RE: Gourmet's Delight Mushroom

Enclosed are revised plan sets and reports for the above referenced project. The enclosed plans respond to the Township Engineer's review letter dated 23 September 2016. Following are responses to the comments in the review letter. The comments from the letter are listed in normal text. The responses to each comment are indicated in ***bold italic text***.

Hydrograph Report

Wet Pond Routed

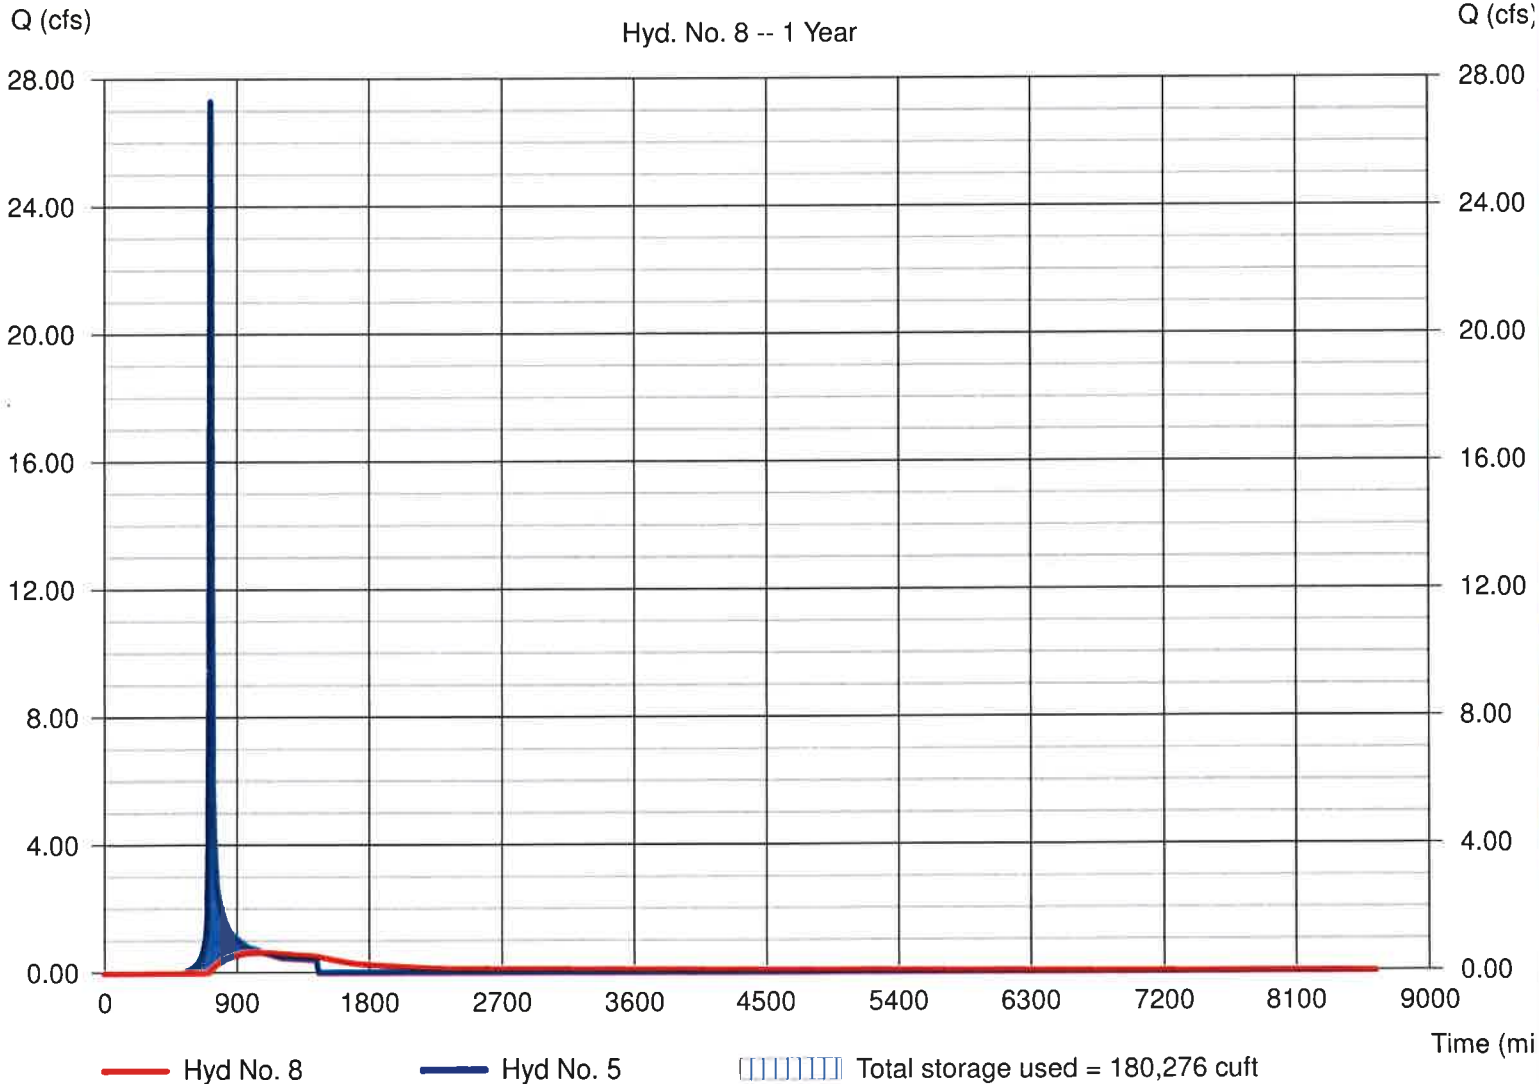
12. While the additional information was provided for the routing, we would like to see a sheet added that starts the routing for the wet basin at elevation 389, as this will confirm that the volume of the wet pond [volume below 389] is not being considered as part of the basin routing.

As a result of the adjustments to the Drainage Area #1 BMP design, the weir elevation is now at 388.5. The attached Page #27 from the SW report documents that the stormwater routing started at that elevation and now credit was taken for any BMP volume below that point.

Storage Indication method used. Wet pond routing start elevation = 388.50 ft.
